MODEL
2017-2019MY
Cadenza (YG)

NUMBER
204 (Rev 1, 07/14/2021)

TECHNICAL SERVICE BULLETIN

**PANORAMIC SUNROOF SLOW TO CLOSE AND/OR
ABNORMAL NOISE WHEN CLOSING**

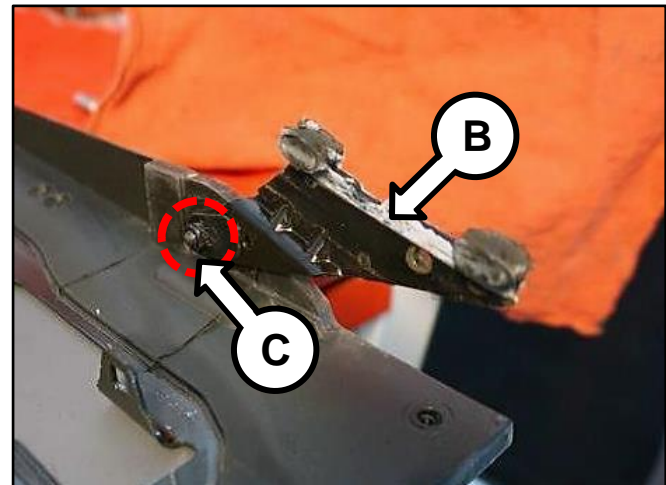
- 3a. Lay the glass on a soft, flat protected surface with the tilt levers (B) facing up.
- 3b. Remove the tilt lever(s) (B) retaining nut (C) and replace the tilt levers on both sides by referring to the application tilt lever table below:

Production Date	Lever Type	Part Number
Until 12/05/2018	A	81651 F6000 81651 F6000
After 12/06/2018	B	81651 F6001 81652 F6001

**Torque specification for nut (C):
 2.95 – 4.43 ft.lbs (4.0 – 6.0 Nm.,
 0.41 – 0.61kgfm)**

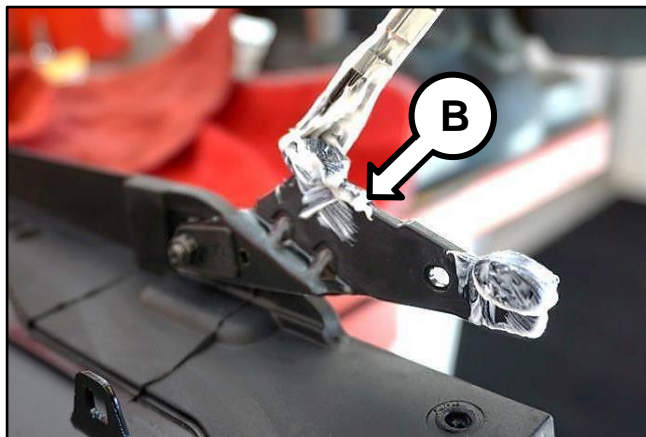
4. Lightly coat the tilt lever shoes (B) using the specified lubricant.

Failure to use the lubricant specified on page 6 of this bulletin may result in an ineffective or repeat repair.

Do not use Kia Dampening Grease (P/N UM011-CHA052), as it is not compatible with the grease used by the factory.
